Kurri Kurri Battery Recycling Facility

Response to Submissions

Battery Recycling Facility | 129 Mitchell Avenue, Kurri Kurri | SSD 7520

Report J15156RP1 | Prepared for Pymore Recyclers International Pty Ltd | 24 February 2017

Figure 2.1: Process Flow Chart – Foundry Area

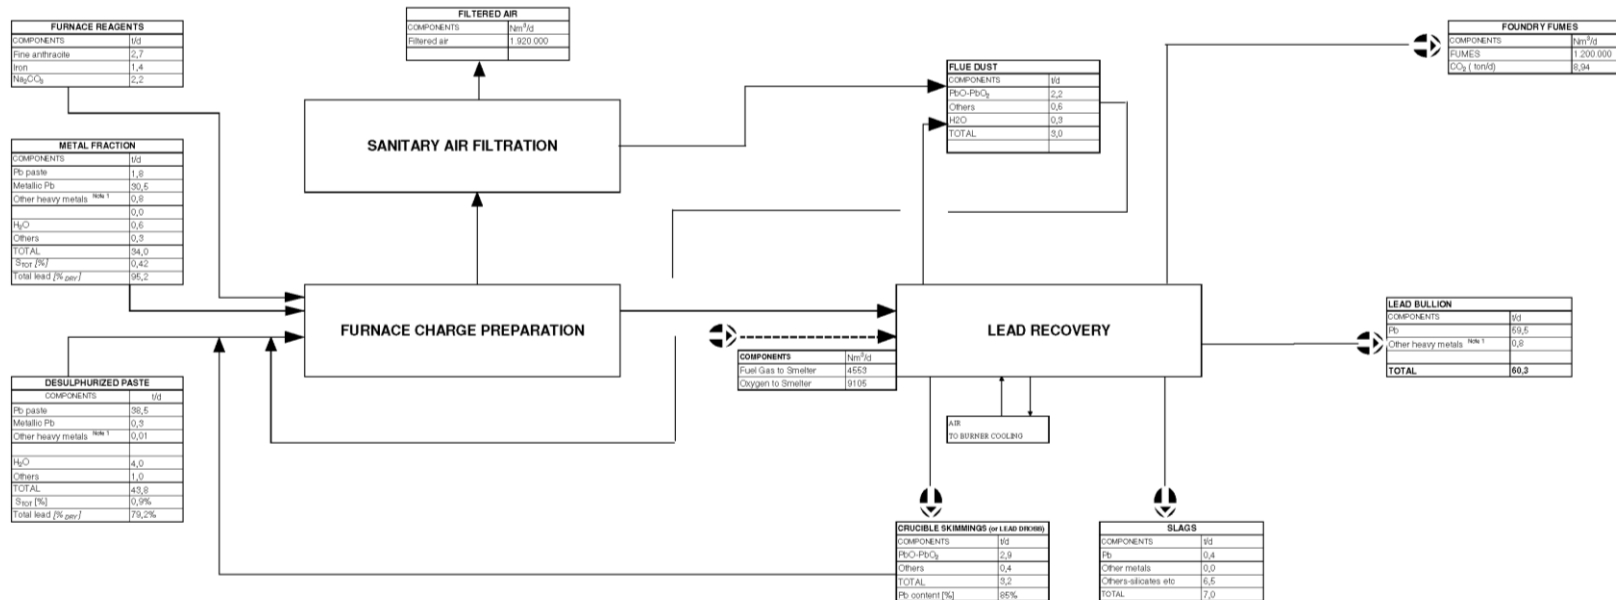
Appendix B of the PHA shows that 3.2 tons per day of “crucible skimmings” will leave the lead smelting process. In this context, “crucible skimmings” is generally consistent with lead dross, which may be a dangerous good. As such, please provide:

Pymore and Engitec confirmed that the term ‘crucible skimmings’ is incorrect and should be referred to as ‘lead dross’. In response to DPE queries for this ‘lead dross’:

- Lead dross is classified as a dangerous good (Class 6.1).
- There should be no accumulation of lead dross, as it is would normally be mixed in the next feed charge into the furnace (refer to the revised process flowchart in Figure 2.1). However, storage space is available for up to 15 days production or 80 tonnes of lead dross.
